APPLICATION NO.	FILING DATE	FIRST NAMED INVENTOR	ATTORNEY DOCKET NO.	CONFIRMATION NO.
10/591,627	09/05/2006	Franz Schwendemann	15407.0001USWO	3314
23552 7590 10/14/2009 MERCHANT & GOULD PC P.O. BOX 2903 MINNEAPOLIS, MN 55402-0903				
EXAMINER YABUT, DANIEL D				
ART UNIT		PAPER NUMBER		
3656				
MAIL DATE		DELIVERY MODE		
10/14/2009		PAPER

Office Action Summary

DETAILED ACTION

Figure Y: View of supporting member within rotor drive in the device of Frey et al.

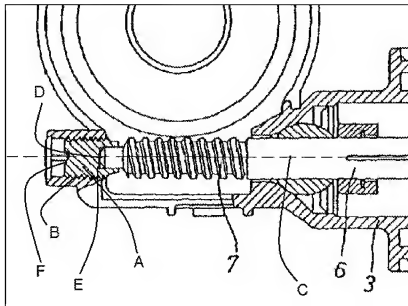
- Supporting member (A; see Figure Y below) that provides an axial force to support the rotor, the supporting member including a(n):
 - Base having a longitudinal axis (near F; Fig. Y below)

- Base of the supporting member is cylindrically shaped (at A; see Figure Y below) , the cylindrically shaped base defining an outer circumference (near B; see Figure Y below)

- Crosspieces are arranged in several planes, which are axially spaced in intervals (see Figure Y below)

- Rotor has a front face with a radius (D; see Fig. Y below) that rests against a flat stop surface (E; see Fig. Y below) that is formed on the supporting member

- Supporting member has a first end and a second end, the first end including a stop face that contacts the rotor (at E; Fig. Y below), the second having a form closed entrainment member (F; see Figure Y below; see paragraph [0029] lines 8-14)

- Rotor (6) positioned with bearings (see bearings near 6 and 14 in Fig. 1) in the housing (Fig. 1)
- Supporting member (34), which is attached via a form closure (at F; Fig. Y below) on the housing

- Supporting member (A; see Figure Y below) that provides an axial force to support the rotor having radial crosspieces (see paragraph [0029], lines 8-10) having a shape that corresponds to the recesses such that the crosspieces axially insert within the recesses during installation without turning (C2 / L50-58; Andrews).

- Supporting member includes a base (at F; Fig. Y below), and wherein the crosspieces are spaced apart from one another about an outer diameter of the base (Fig. 1; Andrews)
